# Wisconsin Department of Transportation

**Proposal #11: 1133-10-71, WISC 2015 008**  
**DePere - Suamico**  
**Memorial Drive – CTH M**  
**Memorial Dr-Duck Crk NB/IH43 Intchg**  
**USH 41**  
**Brown County**

### Letting of January 13, 2015

This is Addendum No. 1, which provides for the following:

Addendum No. 1  
ID 1133-10-71  
Revised Sheet 21  
December 23, 2014

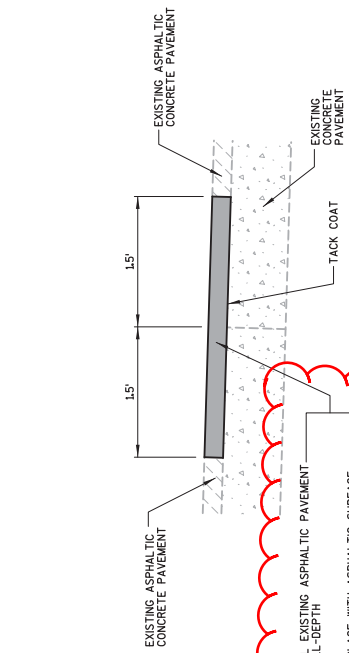
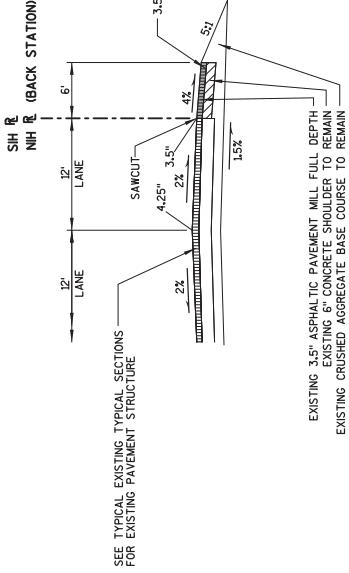
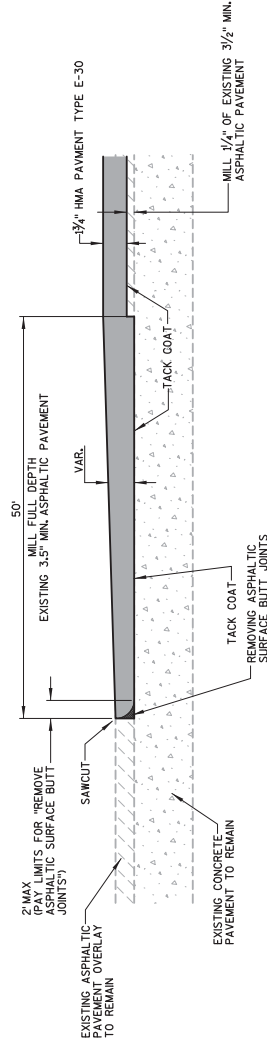
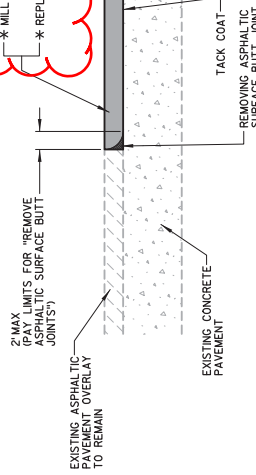
<b>Revised Plan Sheets</b>	
Plan Sheet	Plan Sheet Title (brief description of changes to sheet)
21	Construction Details – Revised Notes
35	Construction Details – Revised Notes
52	Construction Details – Detail Added
115	Plan Details – Revised Notes
116	Plan Details – Revised Notes
279	Traffic Control Staging Sequence and Notes – Revised Notes
294	Traffic Control Details – Revised Notes
305	Traffic Control Typical Section – Stage 1 – Revised Notes
306	Traffic Control Typical Section – Stage 1 – Revised Notes
314	Construction Staging – Stage 1 – Revised Notes
315	Construction Staging – Stage 1 – Revised Notes
345	Traffic Control Typical Section – Stage 2 – Revised Notes
346	Traffic Control Typical Section – Stage 2 – Revised Notes
347	Traffic Control Typical Section – Stage 2 – Revised Notes
348	Traffic Control Typical Section – Stage 2 – Revised Notes
349	Traffic Control Typical Section – Stage 2 – Revised Notes

Addendum No. 1  
 ID 1133-10-71  
 Added Sheet 315A  
 December 23, 2014

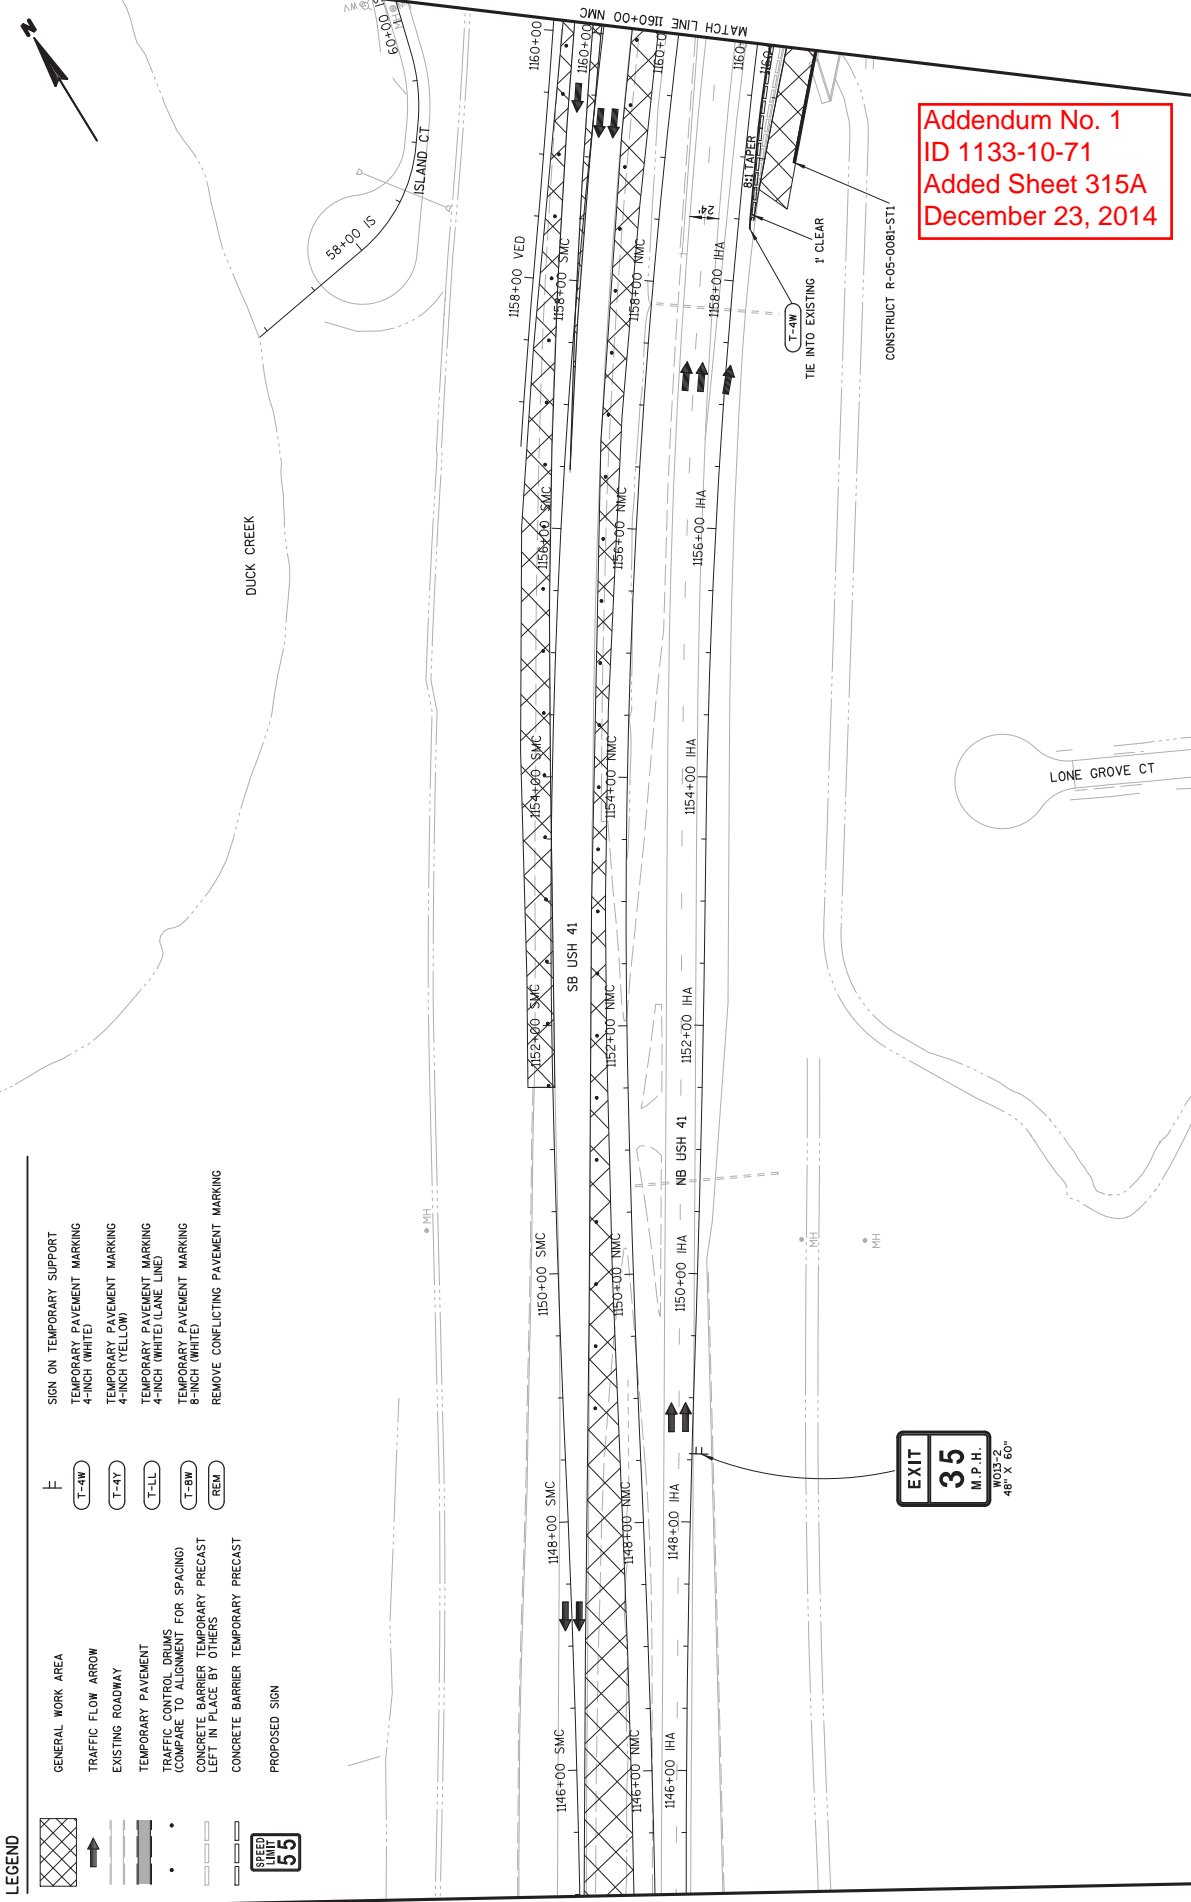
<b>Added Plan Sheets</b>	
Plan Sheet	Plan Sheet Title (brief description of why sheet was added)
315A	Construction Staging – Stage 1 – Added additional substage for beginning of Stage 1
680A	Temporary Signs – Additional Fixed Message Sign Detail
949A	Computer Earthwork Data – Added Additional Earthwork for TWA
949B	Computer Earthwork Data – Added Additional Earthwork for TWA

CONSTRUCT 10' SHOULDER WIDENING  
 ON NORTH SIDE WITH NIGHT  
 CLOSURE DURING STAGE 1
